# Access Compliance Report

## Public Rights-of-Way

Intersection ID: 46308	Main Street: DONNEGAL_FARM_RD	Cross Street: BECKET RIDGE_RD	Location: SE
ADA ID: 131DB5536225	Ramp Type: Perp	Initial Pass/Fail: Fail	Overall Compliance: No
		Severity Score: 10

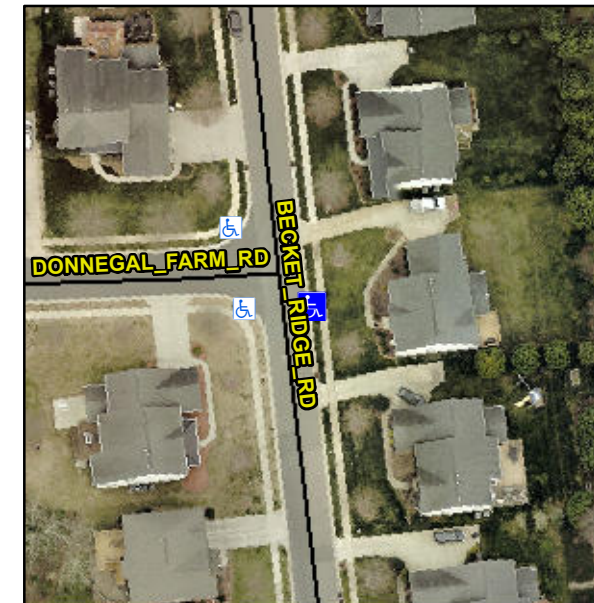
**Not Found, R304.5.1**

Compliance	Description	Data	Compliance	Description	Data
N/A	Ramp Length (in)	48.5	Yes	Ramp Slope (%)	6.6
No	Ramp Width (in)	46.5	Yes	Ramp XSlope (%)	4.1
N/A	Flare Type LT	N/A	N/A	Flare Type RT	N/A
N/A	Flare Slope LT (%)	N/A	N/A	Flare Slope RT (%)	N/A
N/A	Flare Traversable LT?	N/A	N/A	Flare Traversable RT?	N/A
N/A	Landing Length (in)	N/A	N/A	DWS Provided?	N/A
N/A	Landing Width (in)	N/A	N/A	DWS Contrast?	N/A
N/A	Landing Slope (%)	N/A	N/A	DWS Length (in)	N/A
N/A	Landing X Slope (%)	N/A	N/A	DWS Full Width?	N/A
N/A	Landing Curb? (Y/N)	N/A	N/A	DWS Offset (in)	N/A
N/A	Shared Landing?	N/A			
N/A	Gutter Ponding?	N/A	N/A	Gutter Slope (%)	N/A
N/A	Gutter Lip Ht (in)	N/A	N/A	Gutter X Slope (%)	N/A
N/A	Painted X Walk1?	No	N/A	Painted X Walk2?	N/A
	X Walk 1 Direction	To W		X Walk 2 Direction	N/A
N/A	X Walk 1 Width (in)	N/A	N/A	X Walk 2 Width (in)	N/A
	X Walk 1 Slope (%)	2.8		X Walk 2 Slope (%)	N/A
	X Walk 1 X Slope (%)	4.1		X Walk 2 X Slope (%)	N/A

**Remove & Replace Entire Ramp.**
